SUBMISSION

a written submission by way of objection

RE: DA 2023 1289
1112-1116 BARRENJOEY ROAD PALM BEACH
WRITTEN SUBMISSION: LETTER OF OBJECTION
SUBMISSION: TULLOCH

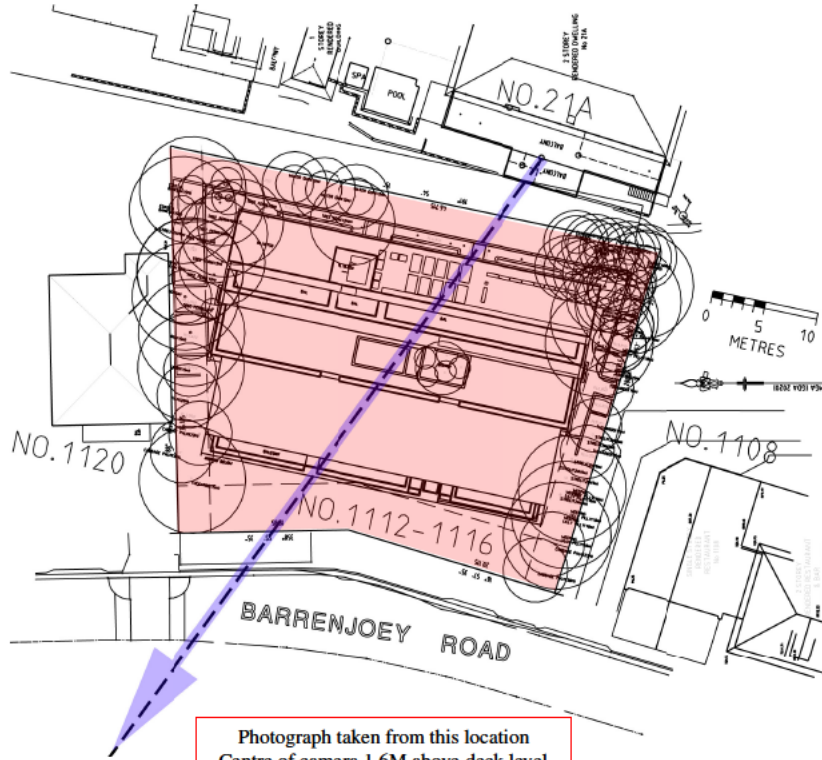
Council will also note the unacceptable visual outcome to the highly used zones within my client's property, by the extensive zones of proposed Roof Mechanical Plant. I contend that a large portion of the proposed plant can be relocated to ground floor and to the basement to areas. Council will note that an 8.5m HOB built form greatly assists in obscuring the remaining roof top plant. A more compliant Rear Setback would also greatly assist with this poor outcome.

EXISTING & PROPOSED (Wire Frame) VP 1

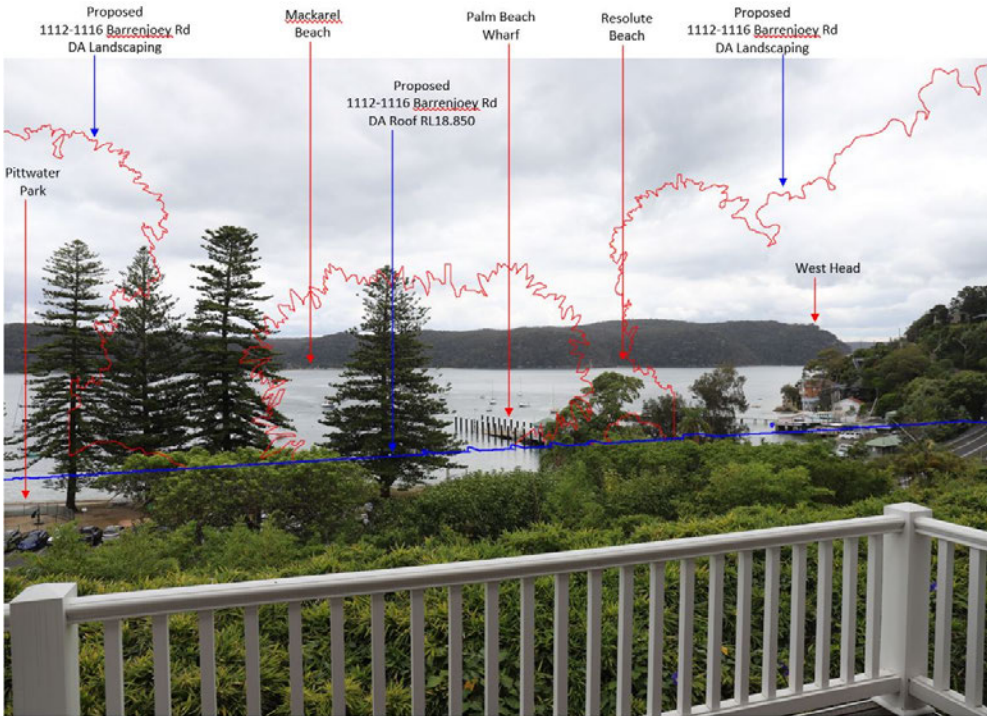
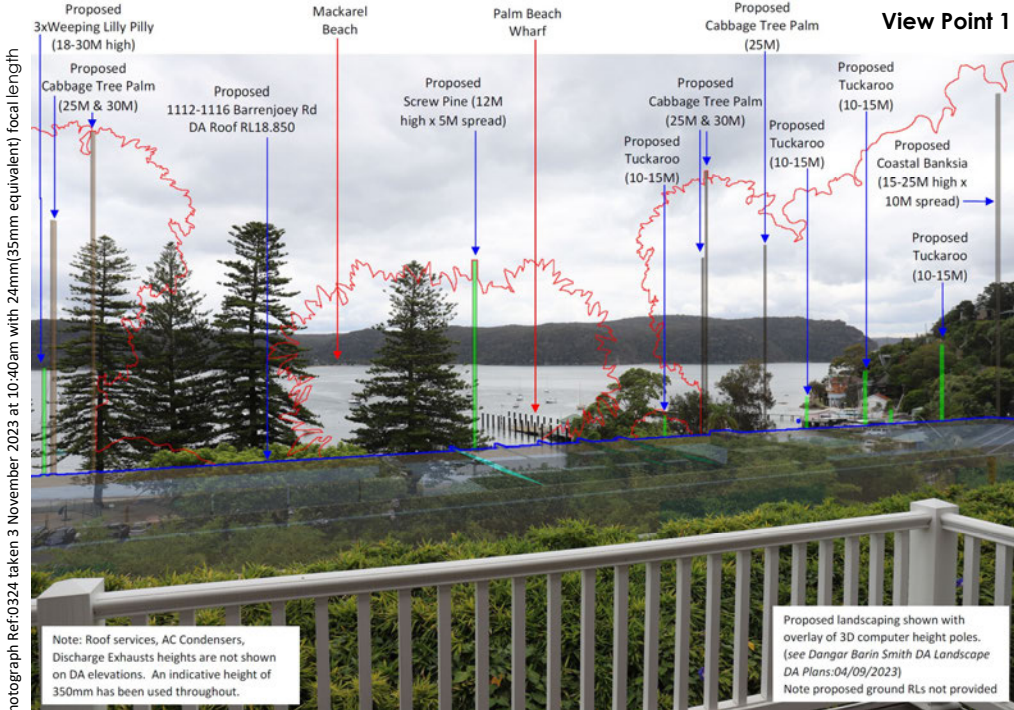
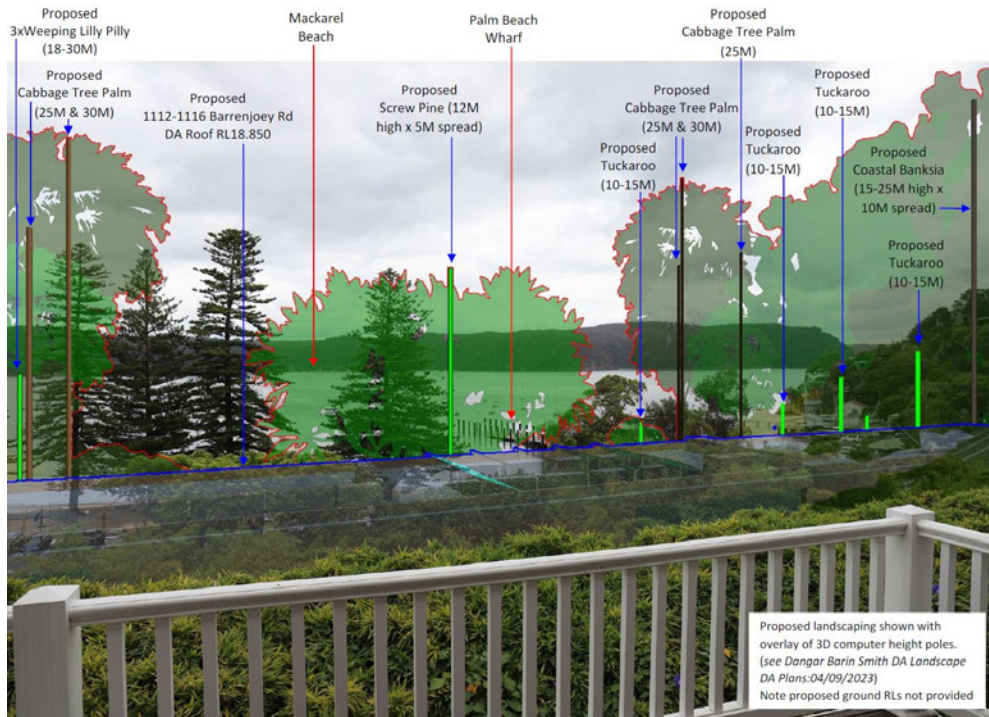
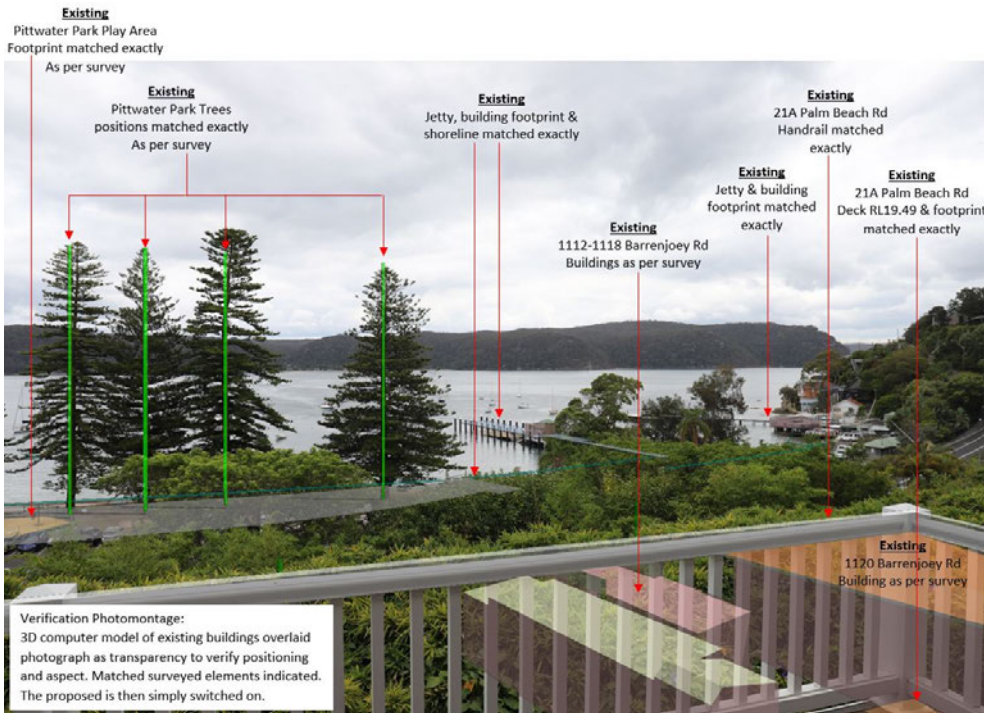
1. There are adverse view loss impacts caused by the proposed non-compliant built form. The loss is of the beach and land/water interface to Pittwater.

2. There are adverse view loss impacts caused by the proposed tree canopy.

The composite view loss is at the 'severe' level of impact.

To resolve this matter, I contend that the Height of Building must not exceed 8.5m, and landscape species over 8.5m must be deleted from the Landscape Plan and replaced with species that do not exceed 8.5m in height.
